Access Compliance Report

Public Rights-of-Way

(Pedestrian Signals)

Intersection ID: N/A	Main Street:	Cross Street: N/A	Location: N/A
ADA ID: 02EFDF85BACA	Signal Type: Two Push Buttons-APS	Overall Compliance: No	Severity Score: BTN 1:N/A BTN 2: N/A No BTN: N/A
Codes/Mitigation Info/Possible Solution		Field Measurements/Component Compliance

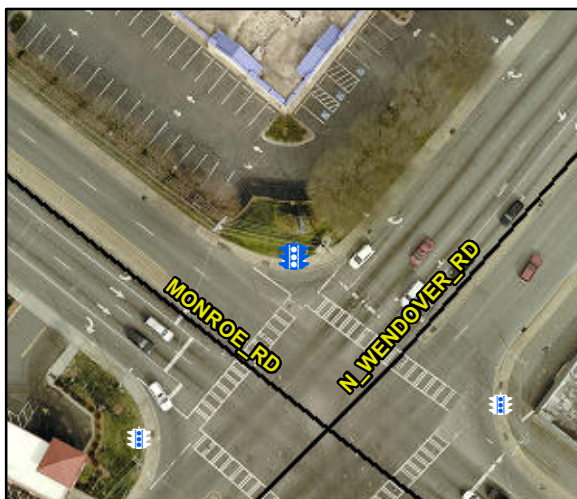
Possible Solutions: Replace Signal Push Button With APS Button on New Post. Remove & Relocate Sign.

PROW/ADA: TMUTCD 4e.08, R404.2, R406.2,

Yes	B 1 Clear Xing Direction?	ClearlyMarked	Yes	B 2 Clear Xing Direction?	ClearlyMarked
	B 1 Crossing Direction	To SW		B 2 Crossing Direction	To SE
No	B 1 DistanceTo XWalk (in)	114.0	No	B 2 DistanceTo XWalk (in)	91.0
Yes	B 1 DistanceTo Curb (in)	69.0	Yes	B 2 DistanceTo Curb (in)	69.0
Yes	B 1 Diameter (in)	2.0	Yes	B 2 Diameter (in)	2.0
